## **IGNITION COIL TECHNICAL INFORMATION** 880033

Technical information n°3

March 2<sup>nd</sup>, 2018

047 905 104 A 047 905 104 B

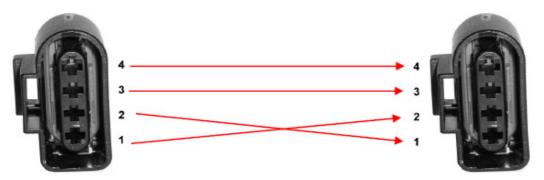
This coil rail can replace two Skoda p/n:

- 047 905 104 A
- 047 905 104 B

There are two different type of connection. In particular:

- 047 905 104 A: connection as per usual application
- 047 905 104 B: using ADV 002 connector (included). Exchange pin 1 and 2.
